West Monkton Parish Council

Comments in respect of the MH2 Vision Document April 2023

District Centre

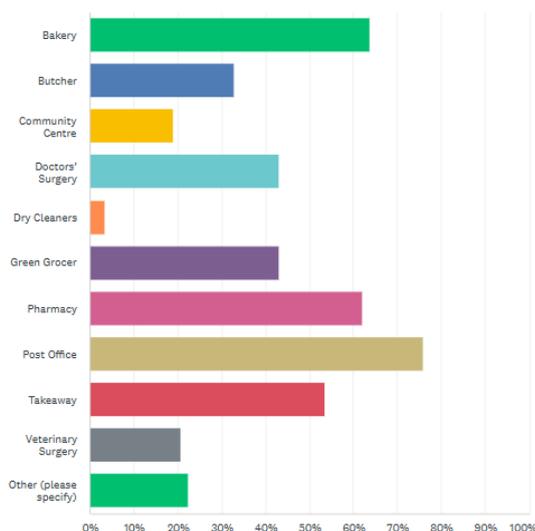
- A sufficient number of retail units should be included in the District Centre for both the MH1 and MH2 development as no retail units have been delivered as planned in MH1.
- The Core Strategy Policy SS1 Monkton Heathfield states that:

- The Vision Document includes:
 - 2340m² offices
 - 800m² community hub
 - 3400m² retail
 - 160m² mobility hub
 - 400m² energy centre
- The vision document provides significantly less retail than that required in policy SS1. Although it is accepted that there has been a decrease in demand for retail, there has been an increase in demand for leisure facilities, restaurants, cafes and takeaways.
- A recent survey conducted by the Parish Council indicates a demand for the following shops in the District Centre:

- All properties in the District Centre should have identified uses and vents for takeaways should be included. Offices above retail is preferred by the Parish Council.
- It isn't clear in the masterplan where the energy centre is going to be, this should be delivered in an early phase.
- Marketing plan / company should be in place for all mixed use, employment and retail land included in the development.
- Electric charging points should be included in the District Centre

Design

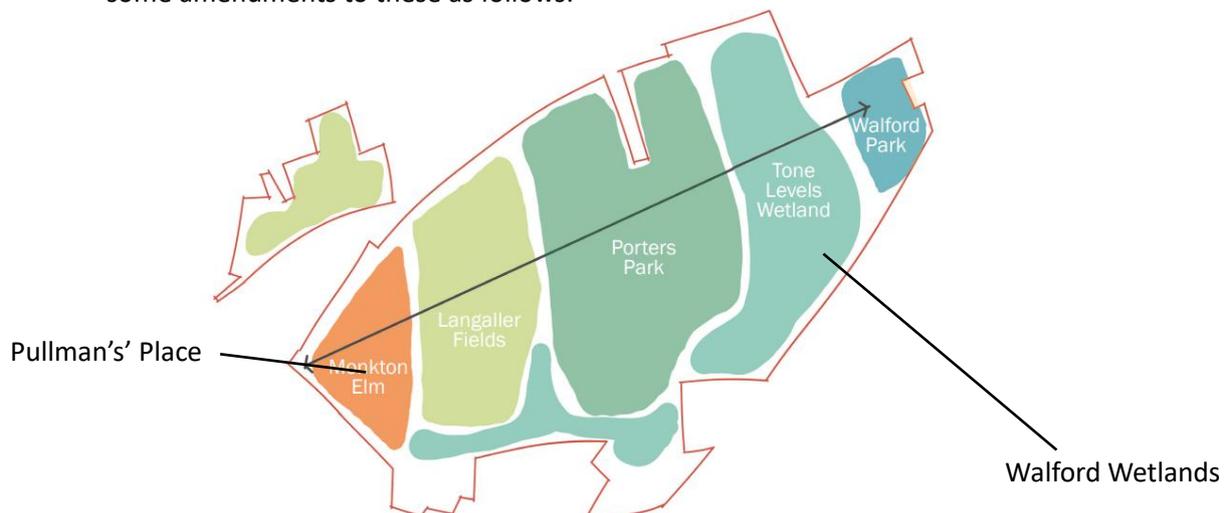
- The size of gardens in the illustrative sketches of the District Centre indicate large gardens, can the anticipated average size of garden in the development be confirmed?
- As the existing use of the land is agricultural, a condition should be included whereby the top four inches of soil is removed and stored on site for use in each garden. This will enable each garden to have at least 4 inches of top soil which will enable growing of vegetables in support of declared climate emergency objectives.
- More tree lined boulevards and open spaces should be included in the development in line with Garden Town principles.
- The West Monkton and Cheddon Fitzpaine Neighbourhood Plan specifies that buildings should not be more than three storeys and the Creech St Michael Neighbourhood Plan specifies 2.5 storeys.
